Docket No.: 80422(302761)

# **AMENDMENTS TO THE DRAWINGS**

# **REMARKS**

App No.: 10/562,007
Docket No.: 80422(302761)
Inventor: Kunihiro Kakihara et al.
Title: HEAT-TREATED RESIN MOLDINGS AND
HEAT-TREATING APPARATUS FOR SOME
ANNOATED SHEET

FIG.4

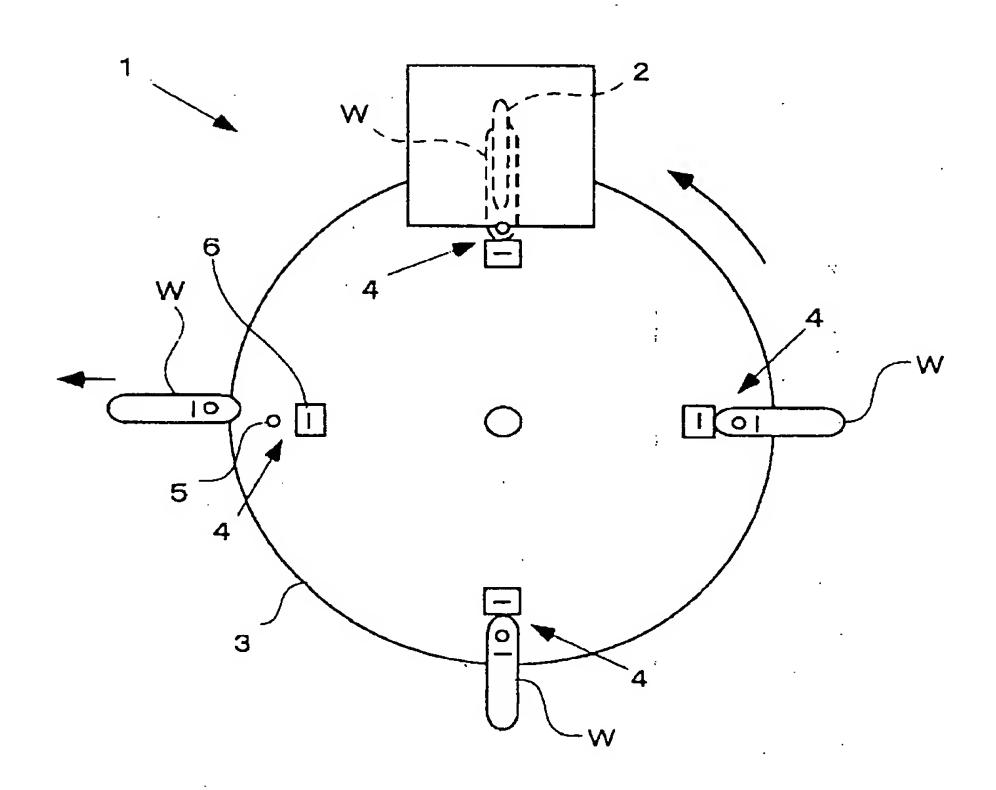
In the Office Action, the drawings were objected for failing to comply with 37 C.F.R. §1.84(p)(5) because Figure 4 does not include items 7 and 8 as mentioned in the written description. (Office Action p. 2)

Figure 4 has been revised to include items 7 and 8. No new matter has been added. It is respectfully requested that this objection be withdrawn.
